Director - Infrastructure Projects
Department of Planning and Environment
Number: SSI 13_6136
Major Projects Assessment
GPO Box 39
SYDNEY NSW 2001

NorthConnex Application Number: SSI 13_6136

Please find below my submission in response to the exhibition of the EIS for NorthConnex.

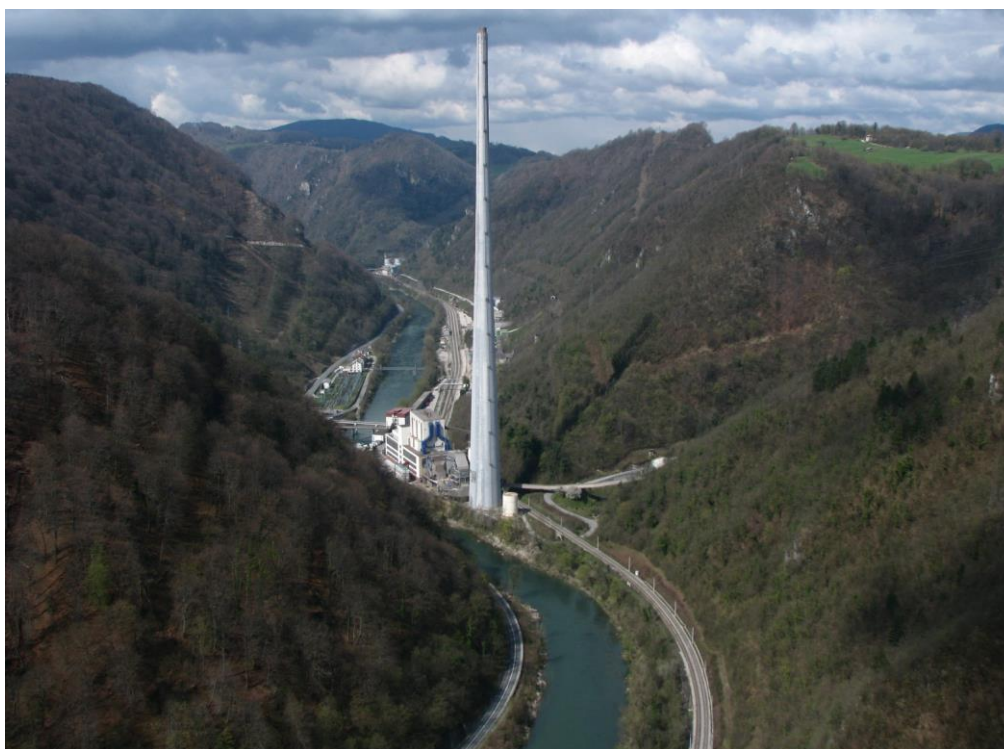
however, most of us have access to Google Earth, and it is quickly evident that whilst there are homes close to some of the existing tunnel vents, none of the stacks are in a purely residential area or an area focused on schools and medical facilities such as Wahroonga. The other critical factors are the topography and the meteorology of the areas, and the length of the tunnel. The Harbour tunnel is used as an example, but the proposed Northconnex tunnel has six times the capacity of the Sydney Harbour

tunnel, the harbour tunnel stack is over 80M high, in a very windy location on the harbour; the water surrounding it on three sides is the flattest possible terrain. It is a shamefully misleading comparison. **Solution:** An independent options assessment process should be undertaken to assess alternative locations for the ventilation stack and portals.
